DEVELOPMENT APPLICATION

PROPOSED MIXED USED DEVELOPMENT:
BASEMENT CARPARK / RETAIL PRECINCT & APARTMENTS (CLASS 7A, 6, 2)

Project
9 MARVELL ST
Client
COBILD

Drawing Name
COVER - CHANGES DRA 01 & 02
Location
9 MARVELL ST BYRON BAY
NSW 2481

Drawing Name
NORTH ELEVATION - CHANGES
Location
9 MARVELL ST BYRON BAY
NSW 2481

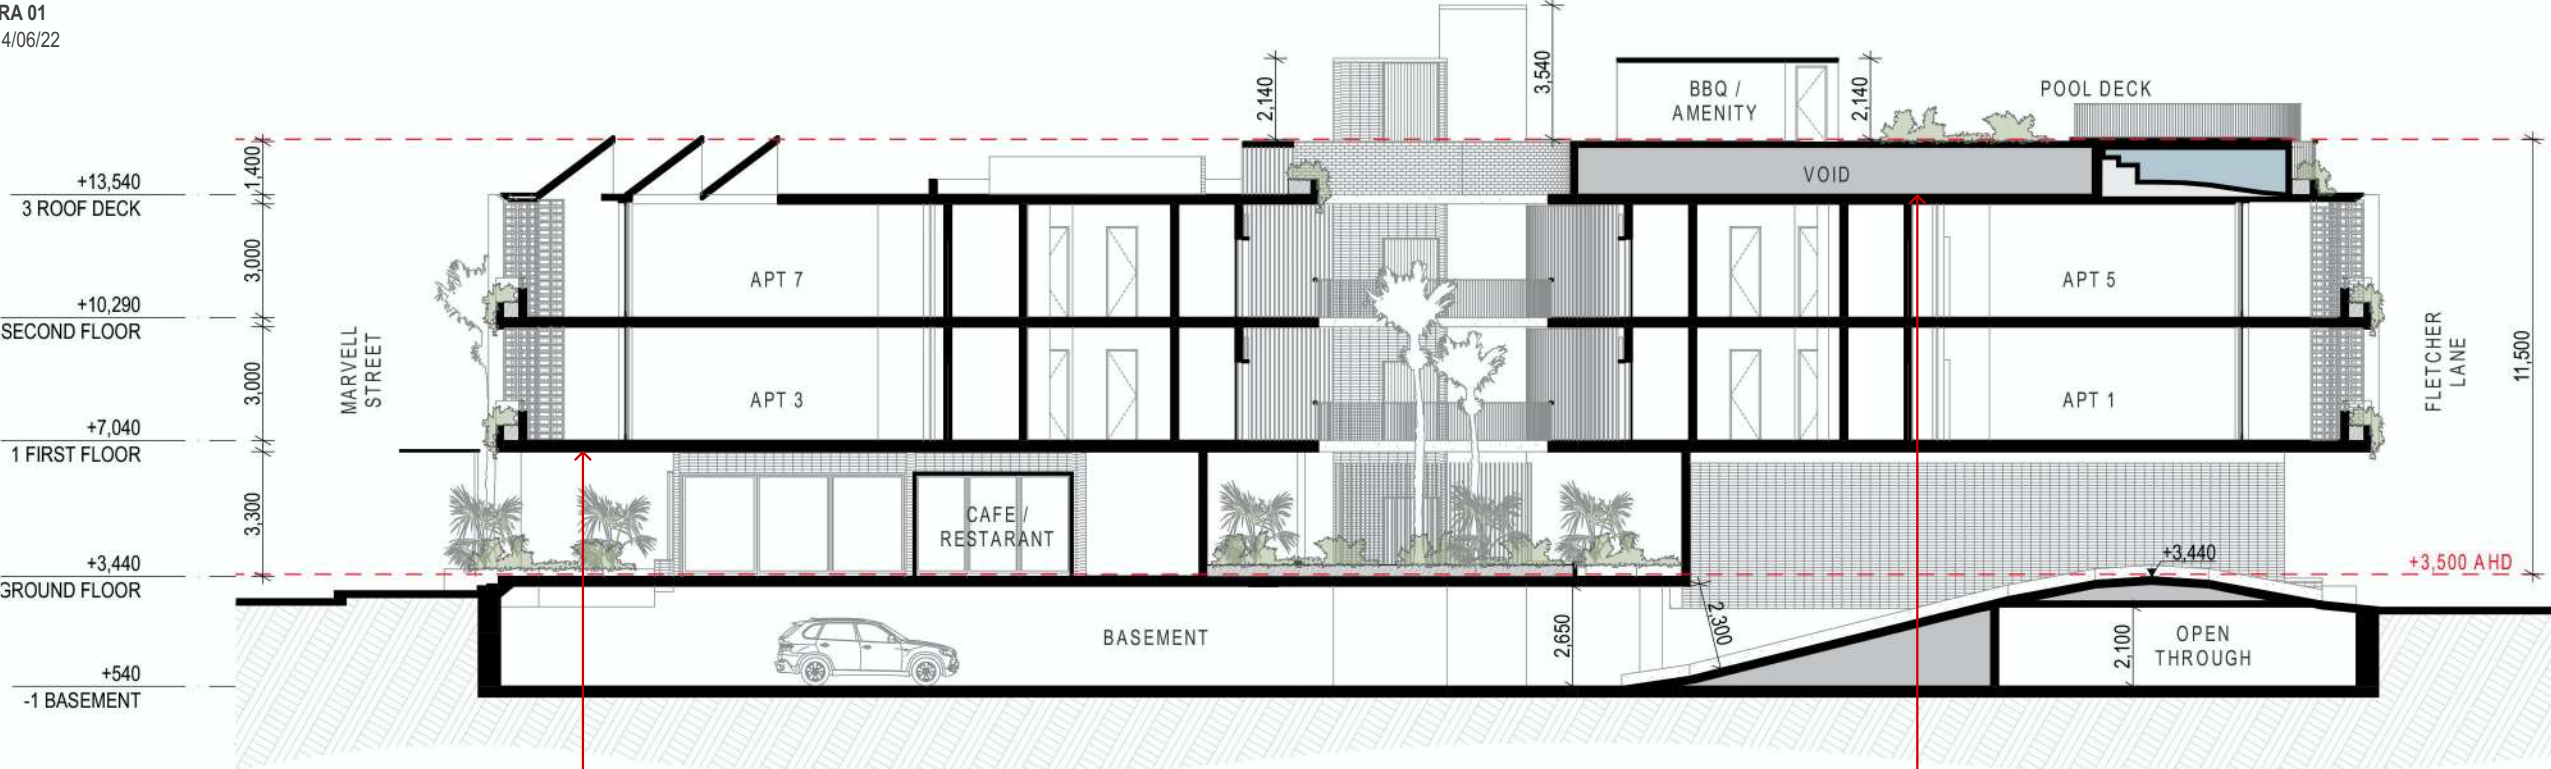
2.01	Address street presence and human scale of ground plane to Fletcher Lane, current design presents some lofty and cavernous spaces (vehicular basement ramp, loading bay).	Addressed in current design
2.02	Consider enlarging void to basement to increased light access and continuity of vegetation between basement a ground level - possibility of palms panted to basement, with green bulk growing at or past ground level.	Addressed in current design
2.03	Consider a discrete location on Marvel St for development signage.	Addressed in current design

2.01
Tilt garage door introduced to Fletcher Lane
reducing open void space, top datum aligned
to windows improving human scale to ground
plane

Drawing Name
LONG SECTION - CHANGES
Location
9 MARVELL ST BYRON BAY
NSW 2481

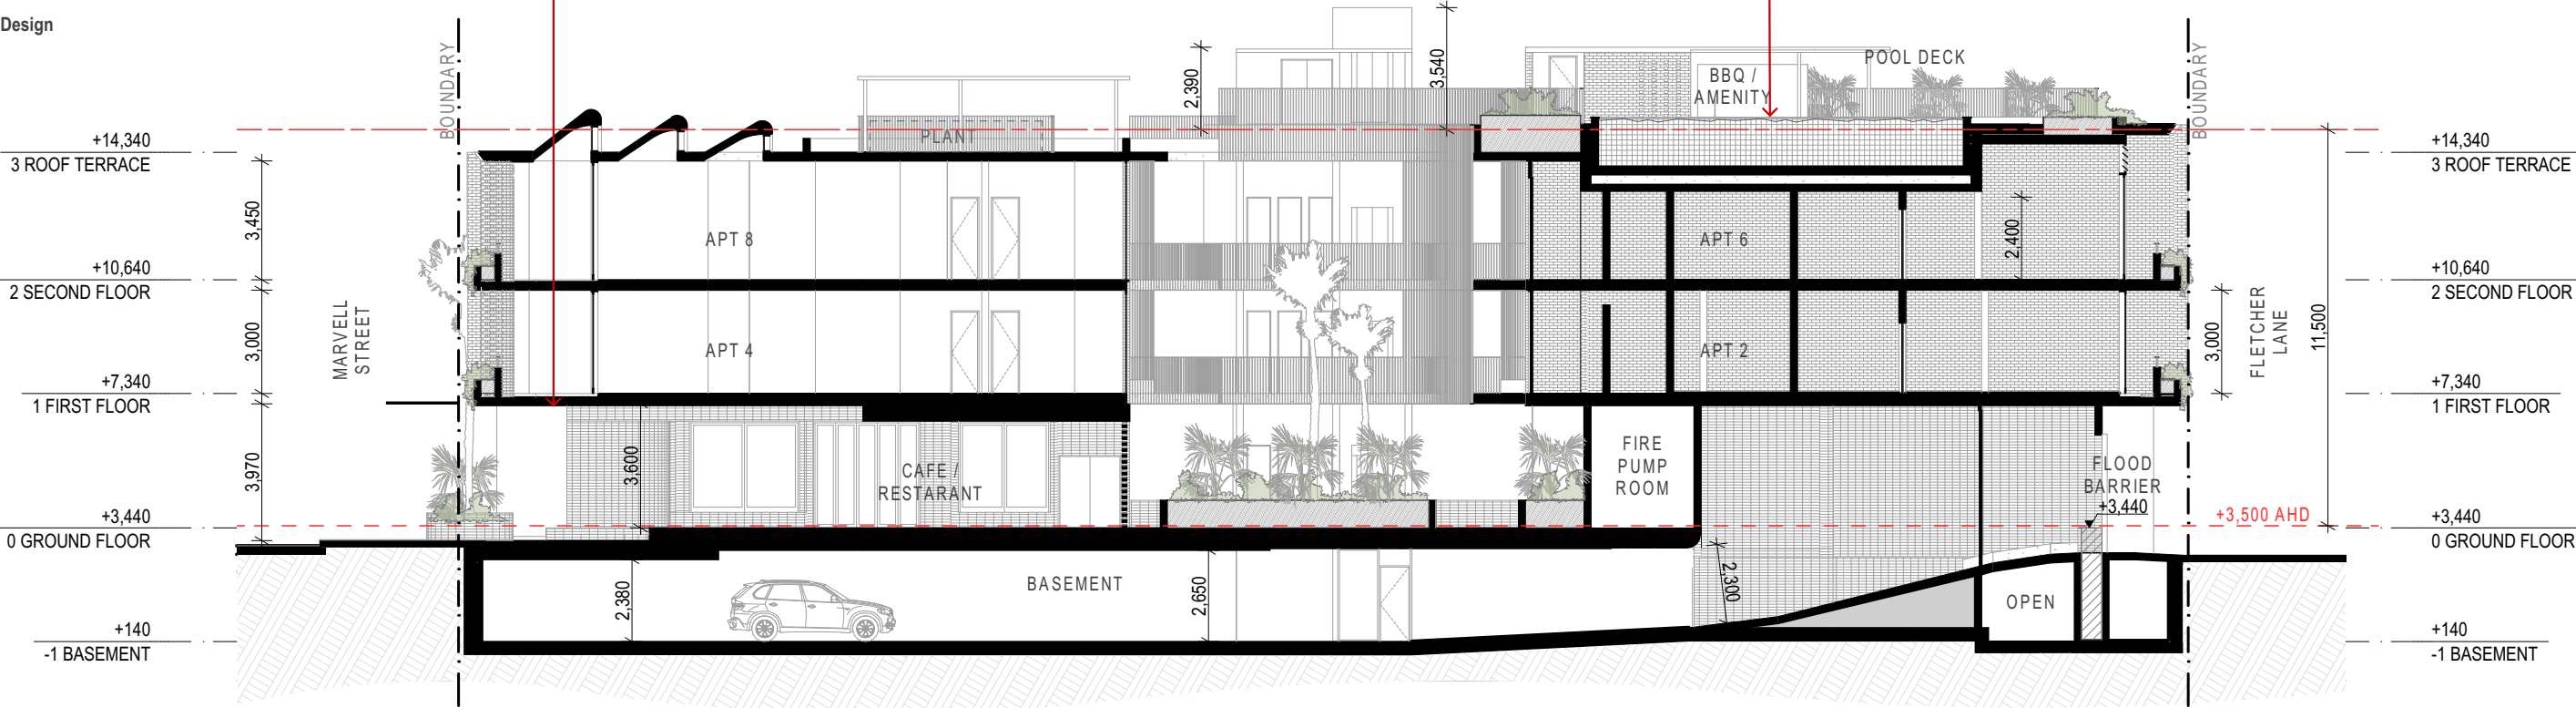
1.08	Consider deleting car space 1 and opening the area to the courtyard, noting that fire egress is not resolved.	Not feasible - not implemented
1.09	Increase the ceiling height at the ground level to conform with DCP and analyse and show the impact that the additional height has on streetscape and solar access to the south side of Marvell Street.	Addressed in current design

1.10	Other options would exist to reduce the overall height of the building with the removal of the roof top void/ pool deck and subsequent lowering of the BBQ, Sauna, Amenities and Pool Room.	Addressed in current design

1.09
Ground floor ceiling height increased from 3300mm to 3970mm at Marvell St and 3600mm at restaurant level - improves light amenity to undercroft and satisfies DCP

1.10
Pool deck reconfigured to maximise ceiling heights to apartments below

Drawing Name
BASEMENT - CHANGES
Location
9 MARVELL ST BYRON BAY
NSW 2481

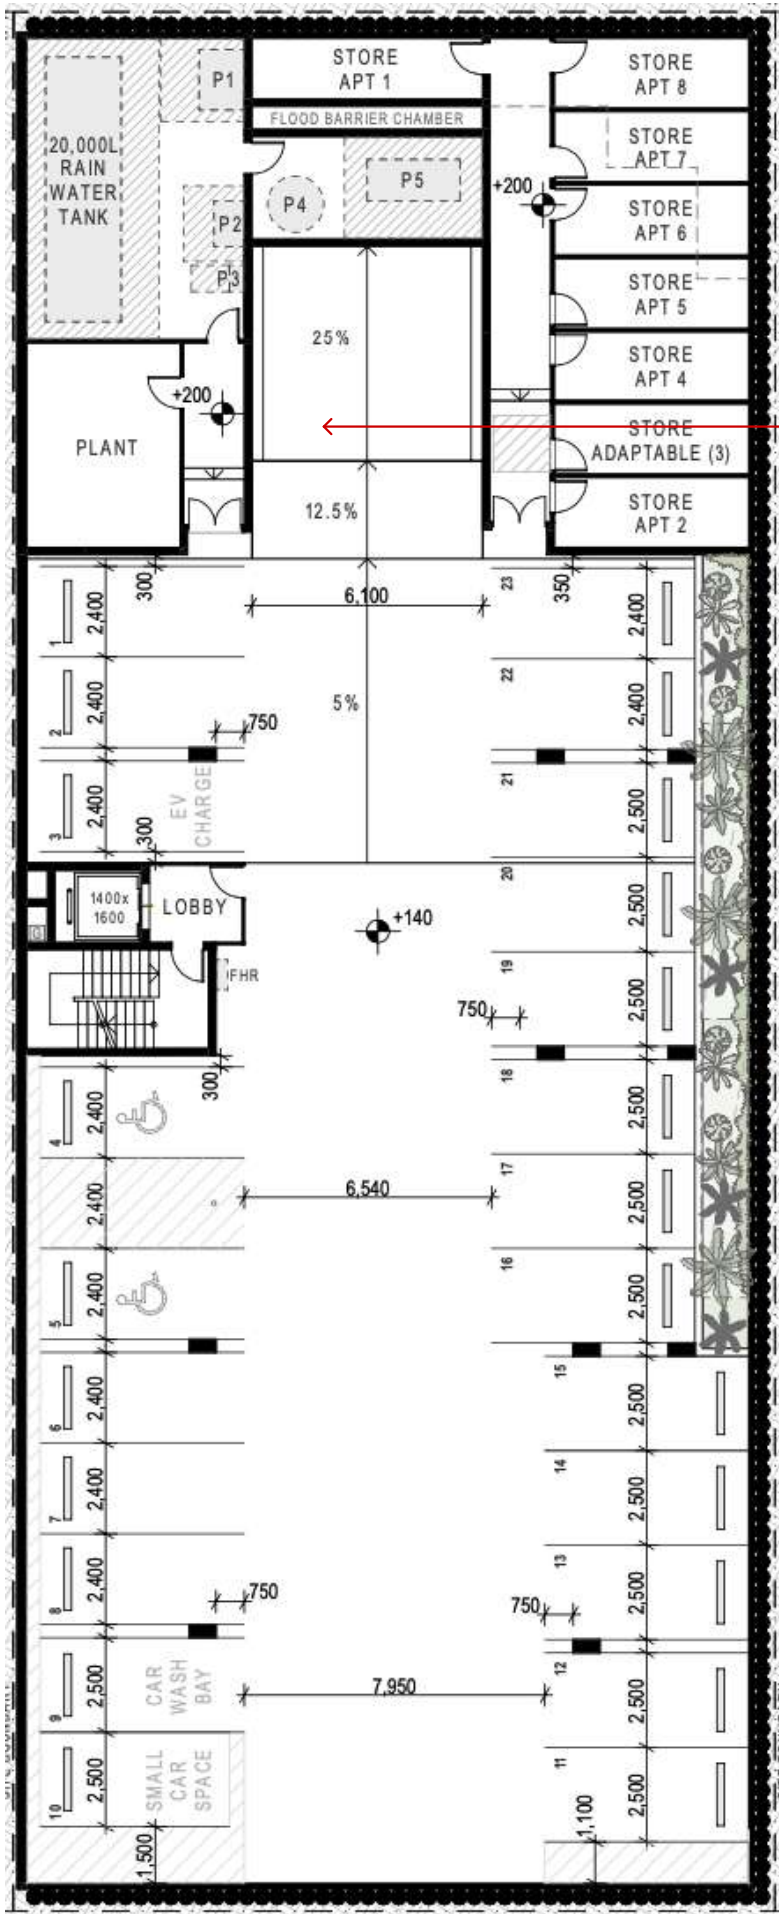
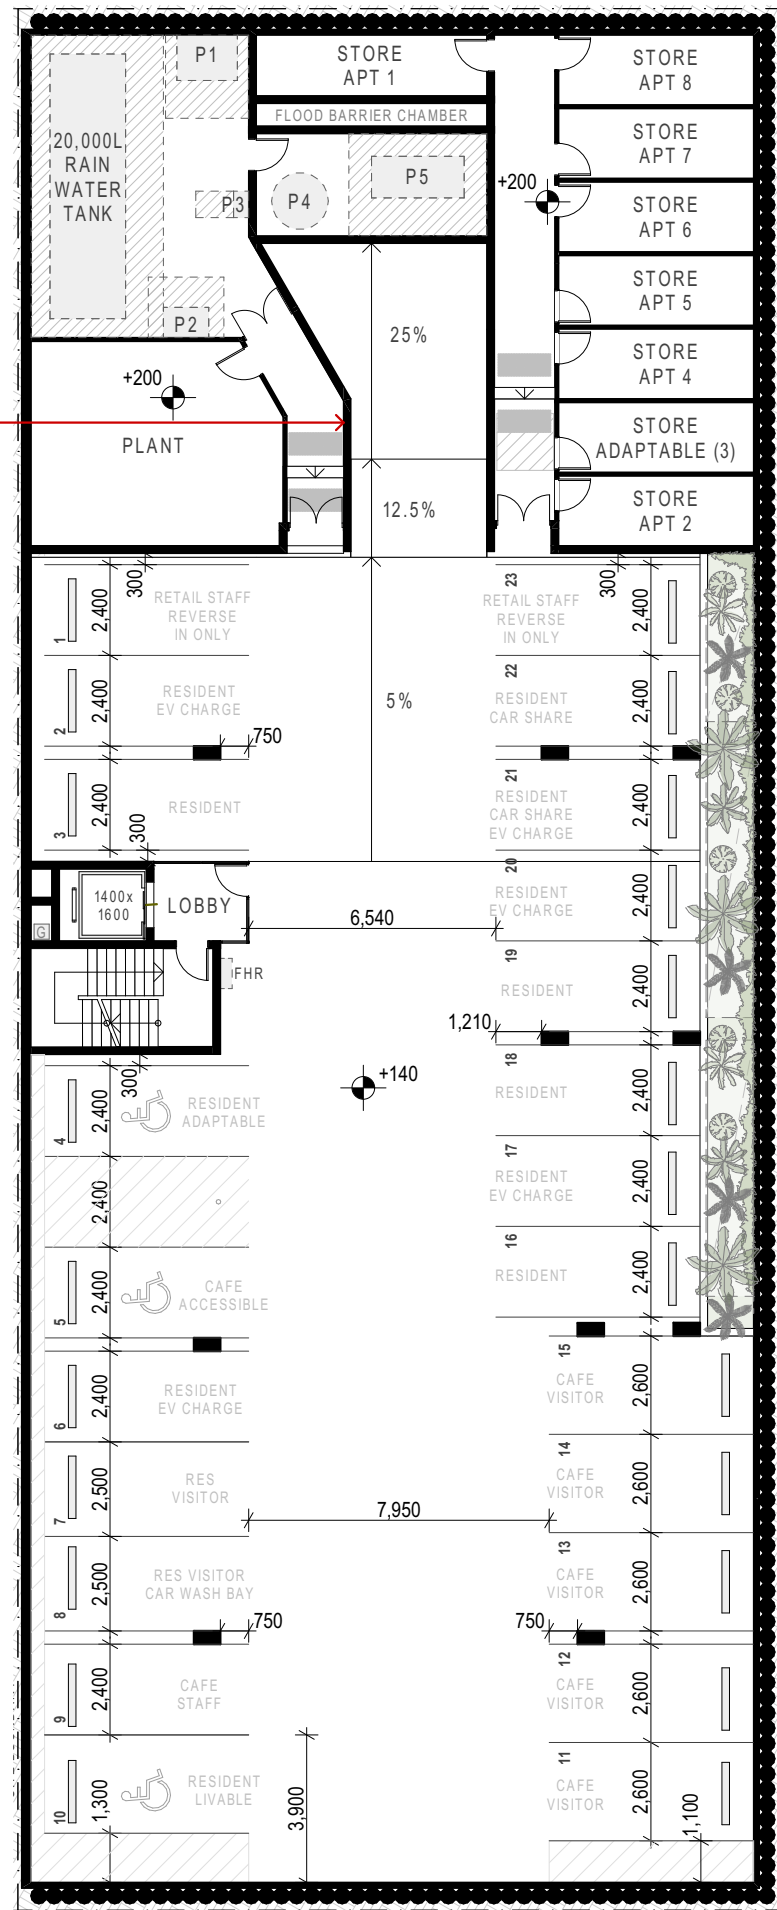
3.01	B1: Narrow ramp and entry as has been approved at 7 Marvell adjoining	Addressed in updated design
3.02	B1: Consider introducing voids adjoining lift and stair core (check fire egress arrangements)	Not preferred - not implemented

3.01
Ramp narrowed to allow for adequate
queuing to Fletcher Lane

Drawing Name
GROUND FLOOR - CHANGES
Location
9 MARVELL ST BYRON BAY
NSW 2481

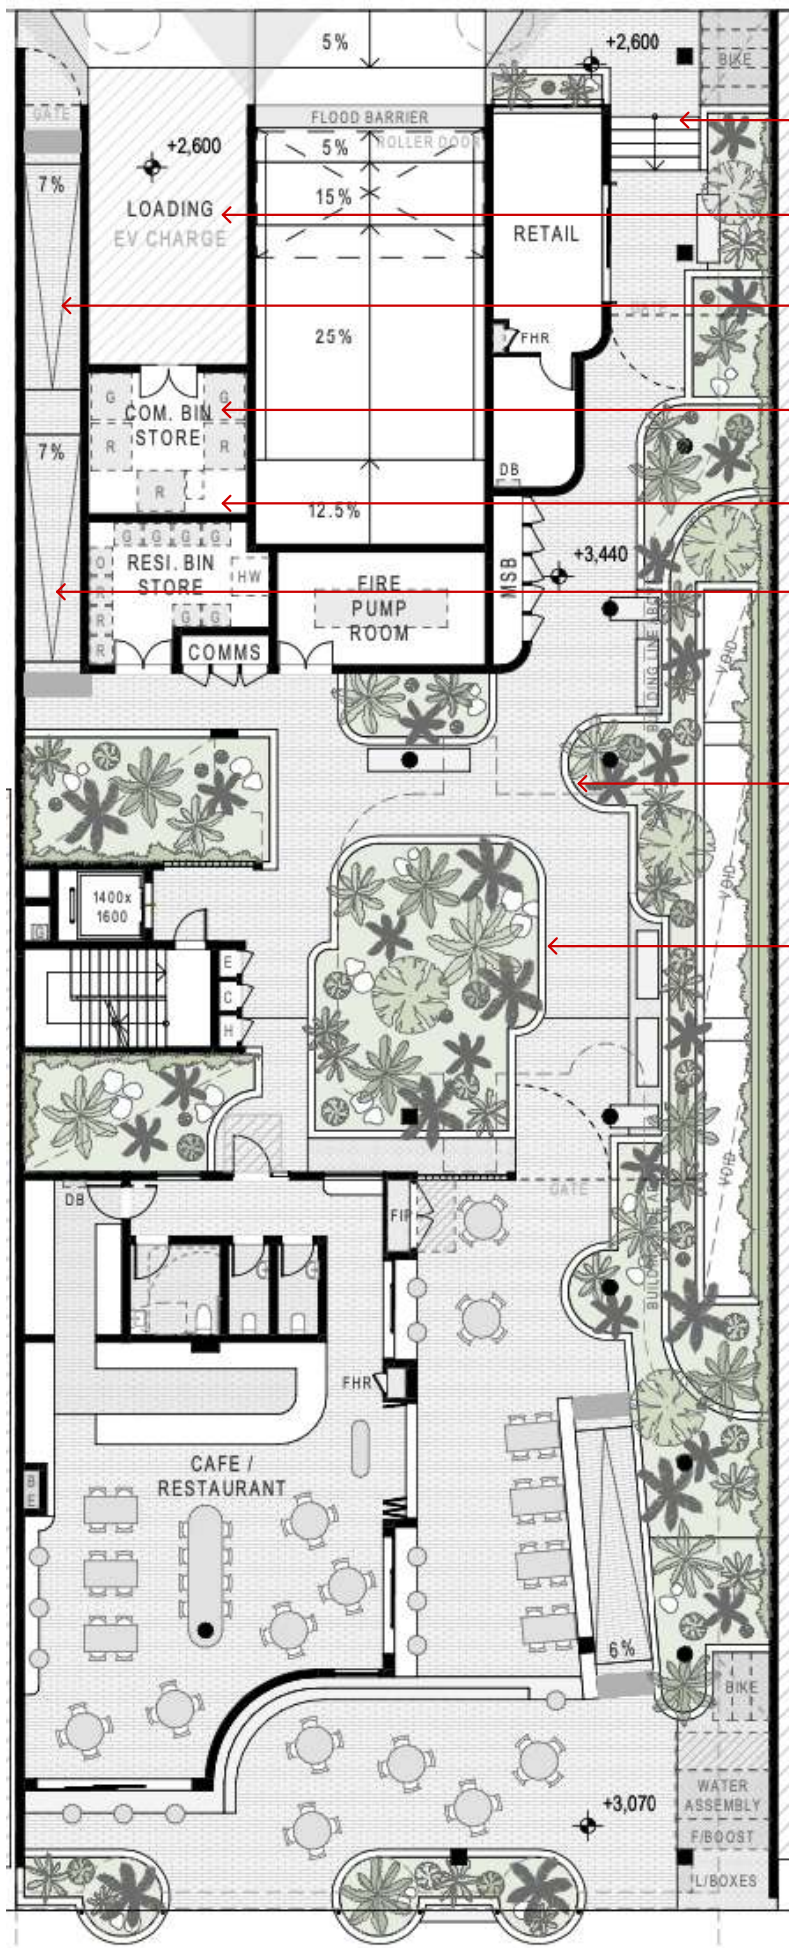
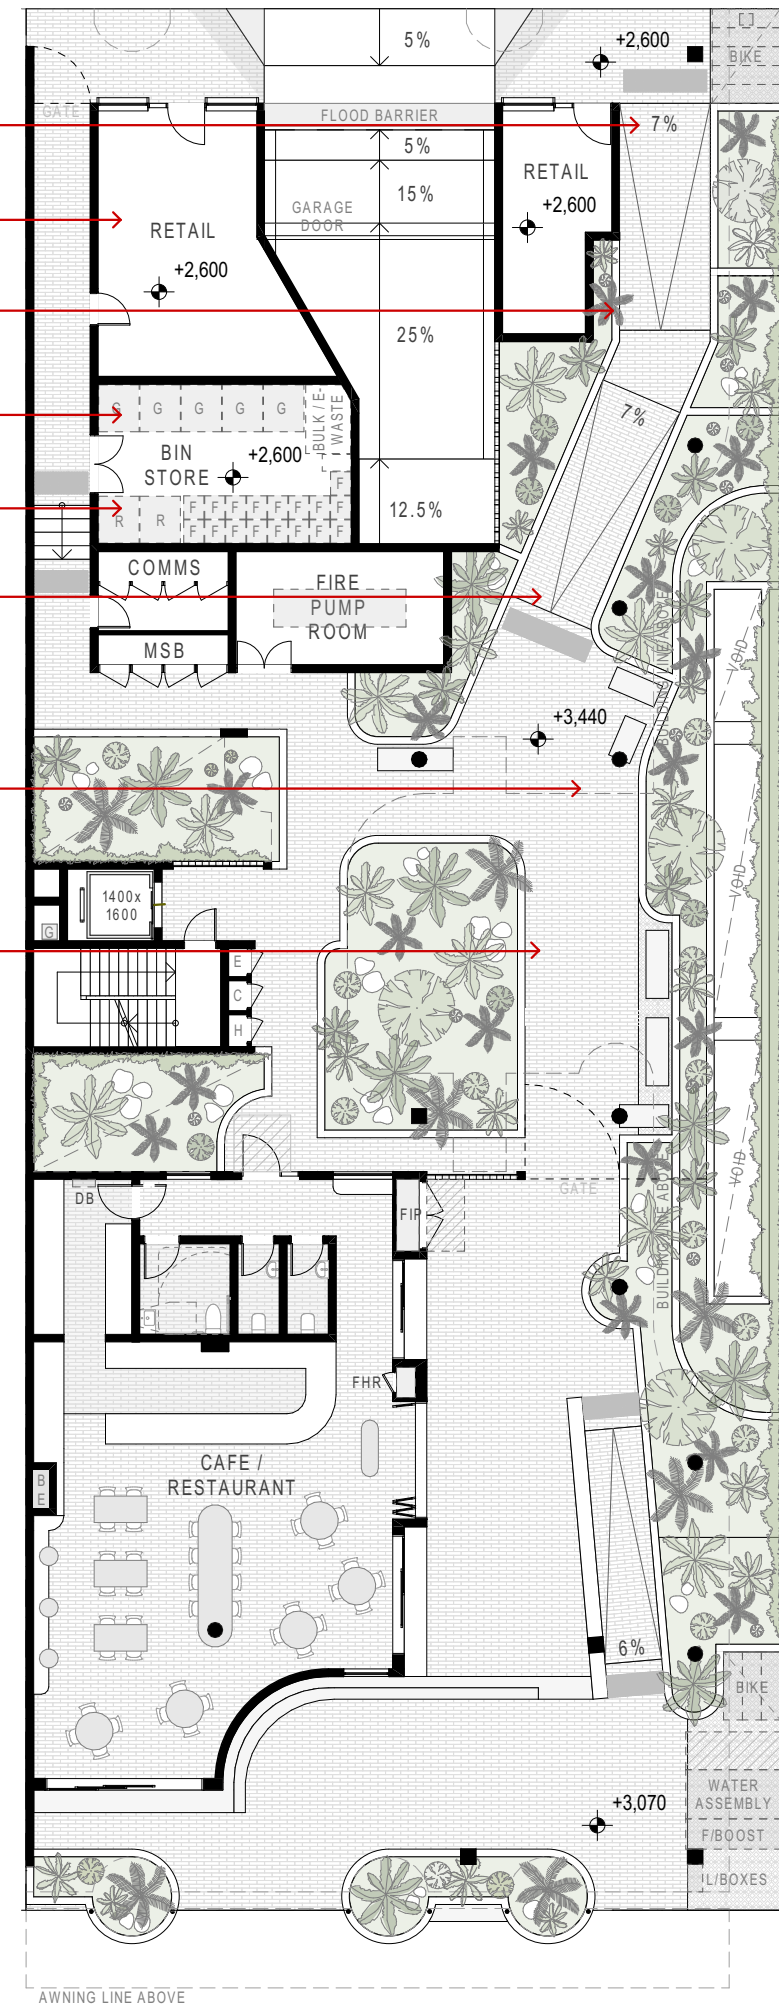
3.03	GF: Relocate pedestrian ramp to the east (DDA)	Addressed in updated design
3.04	GF: Increase retail and active frontage to lane	Addressed in updated design

3.05	GF: Remove stairs	Addressed in updated design
3.06	GF: Narrower car park entry and ramp	Addressed in updated design
3.07	GF: Widen path reduce area of planter to provide less obstructed entry	Addressed in updated design

3.08	GF: Provide a more direct and wider view through	Addressed in updated design
3.09	GF: Reorganise bins- larger commercial bins	Addressed in updated design

3.10	GF: Introduce voids to carpark below	See 3.02
3.11	GF: Simplify planter bed to provide clearer path	Addressed in updated design
3.12	GF: Modify existing crossover to become a loading bay	Updated - noted on site plan

- 3.05 Stair relocated to service corridor to accommodate ease of entry at Fletcher Ln
- 3.04 Loading bay moved to Marvel St, additional retail space added to Fletcher Ln frontage
- 3.03 Pedestrian (DDA) ramp moved to public laneway (east)
- 3.09 Bin store consolidated to single room
- 3.06 Ramp narrowed to allow for adequate queuing to Fletcher Lane
- 3.07 Reconfiguration to improve entry and circulation from Fletcher Ln. Width is maximised with regard to DDA access limitations
- 3.08 / 3.11 Planters reduced to allow for to improve sight lines and pathway through laneway
